**Re: FedEx Ground ABQ Drainage Report and Grading Plan and Drainage Plan
Engineer's Stamp Date 10-20-14 (K09D026A)**

**RE: FedEx Ground ABQ Drainage Report and Grading Plan and Drainage Plan
Engineer's Stamp Date 9-12-14 (K09D026A)**

**FEDEX GROUND ABQ
ALBUQUERQUE, NEW MEXICO**

VINCENT P. CARRICA P.E. #16212	ENGINEER'S SEAL	FEDEX GROUND ALBUQUERQUE, NM POST DEVELOPED DRAINAGE BASIN MAP	DRAWN BY DY
		 5571 MIDWAY PARK PLACE NE ALBUQUERQUE, NM 87109 (505) 858-3100 www.terrawestllc.com	DATE 10-9-14
			2013075-BASINS
			SHEET # C2
			JOB # 2013075

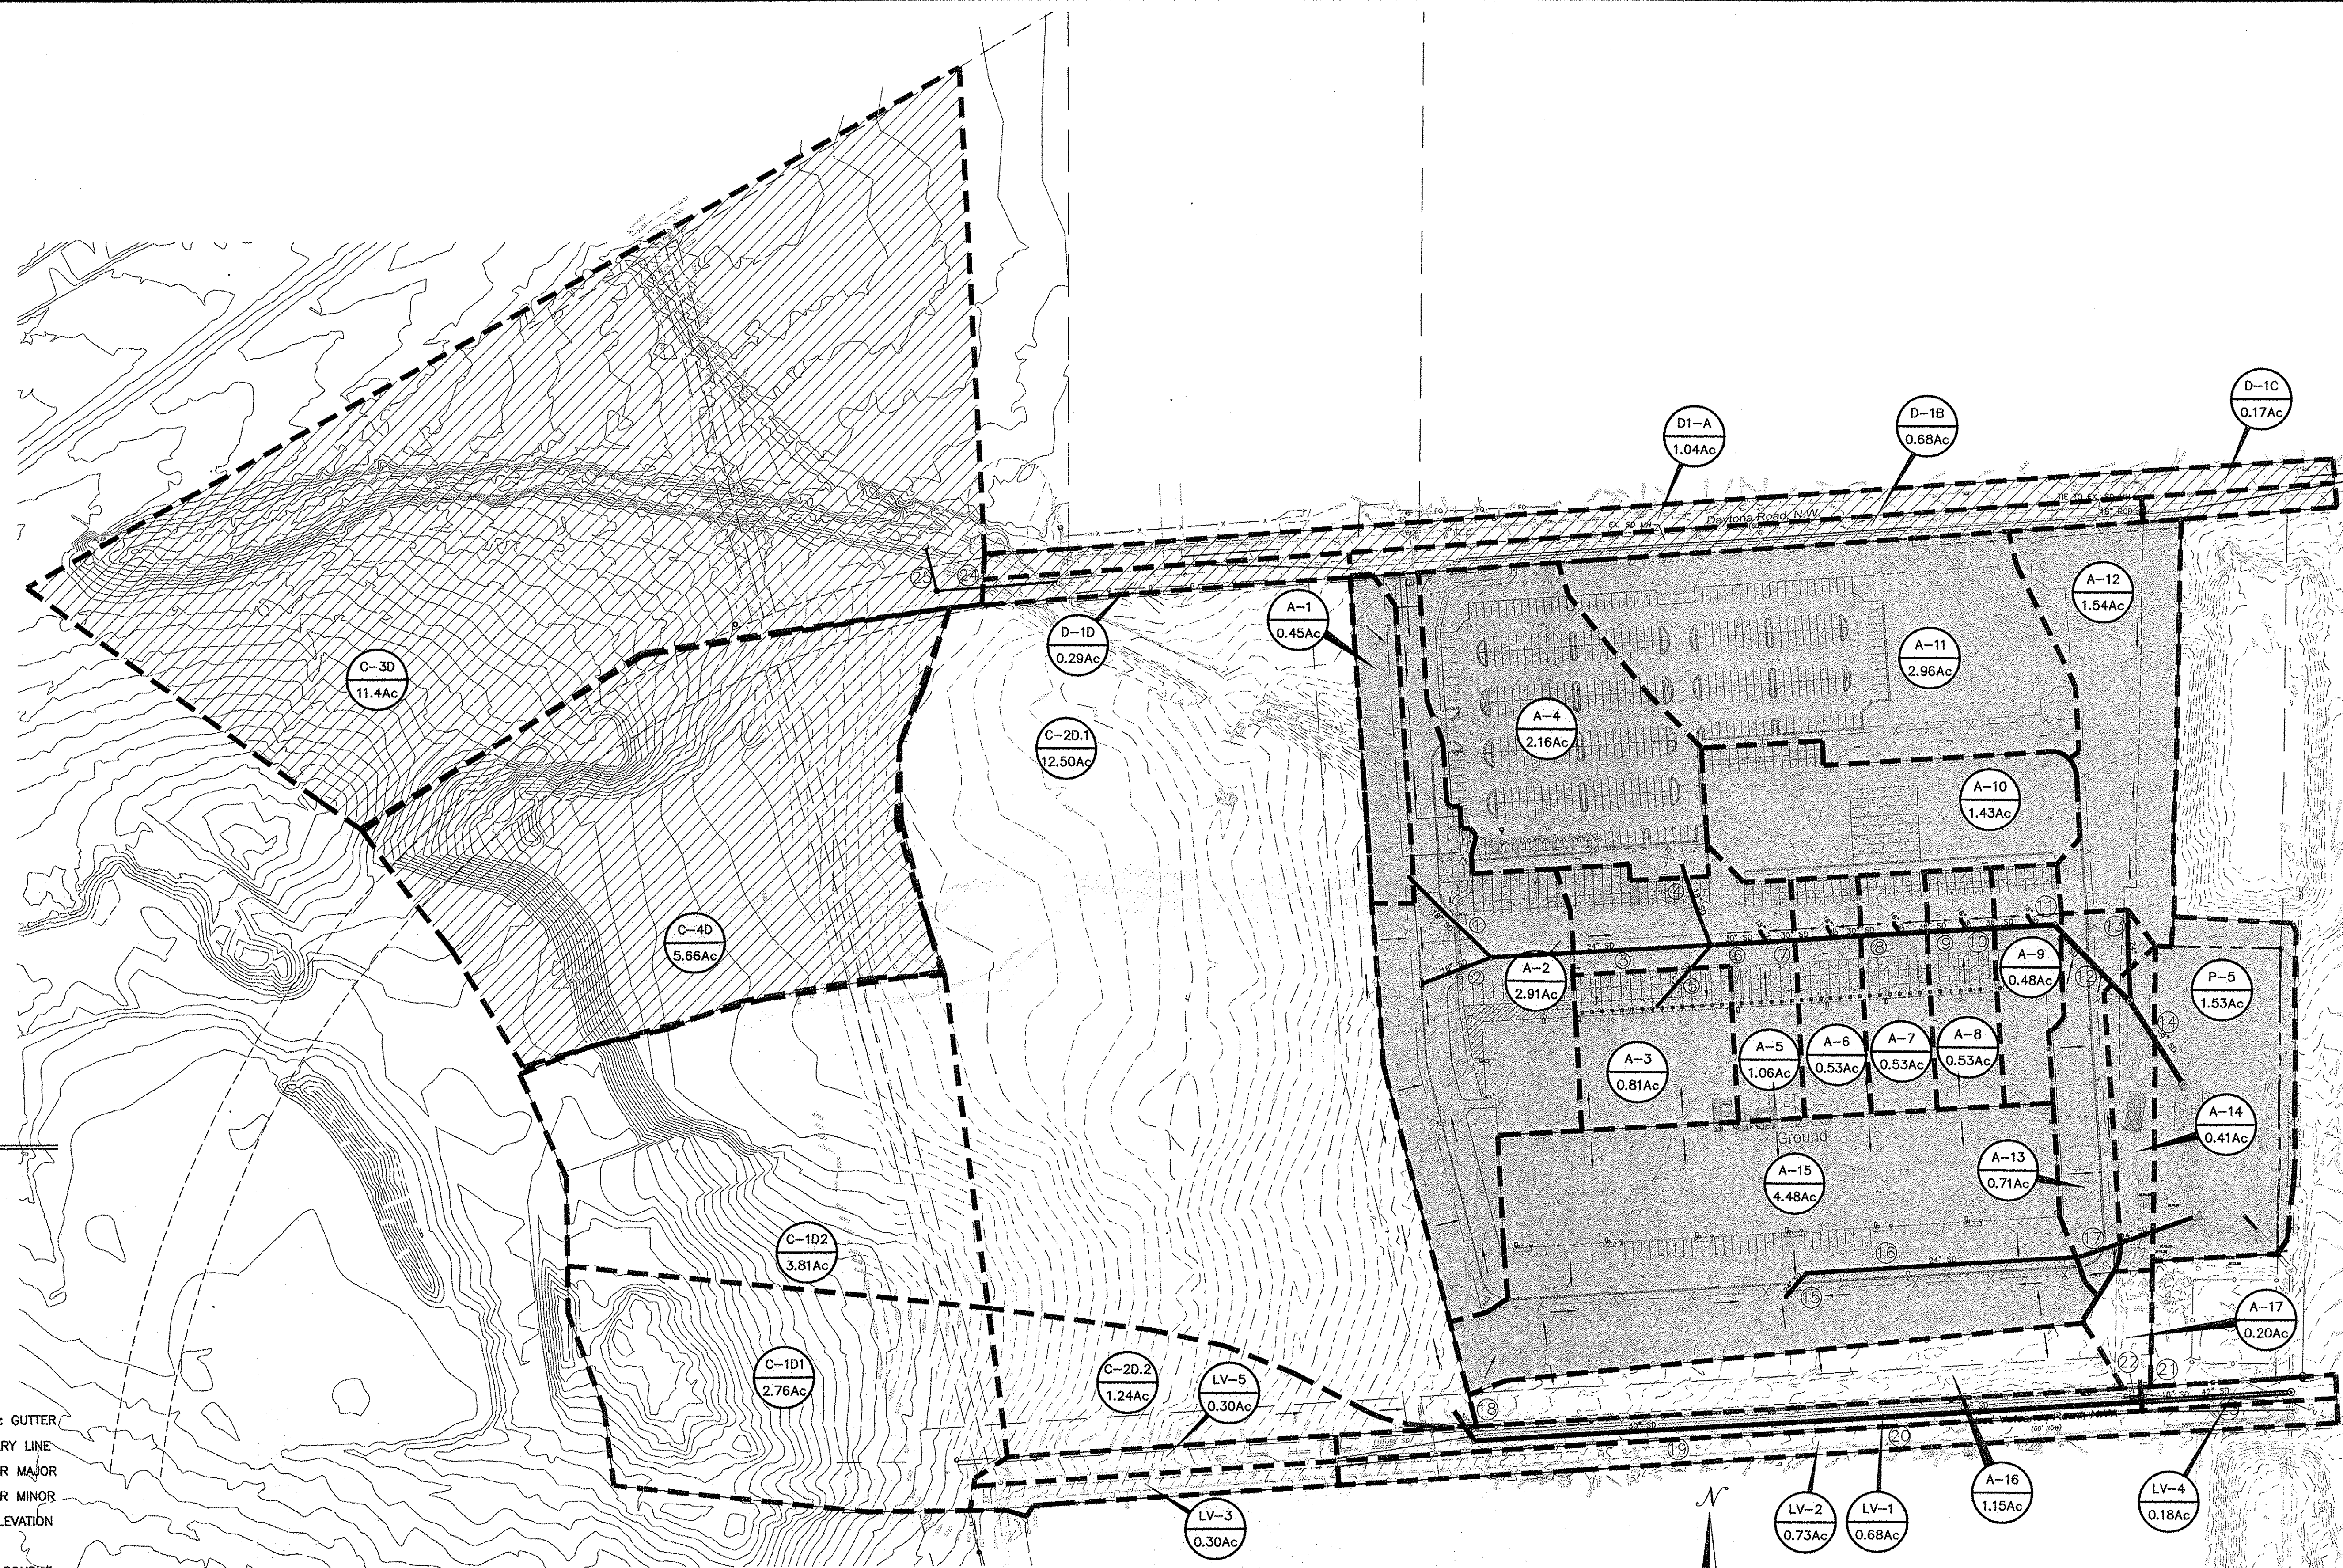
4. Show the storm drainage on the master drainage plan so it is easier to follow the report. Two pipe #20 references are shown. The one by the inlet should be #22 not #20.

Response: The storm drains have been added to the basin map for clarity and the pipe run numbers have been corrected.
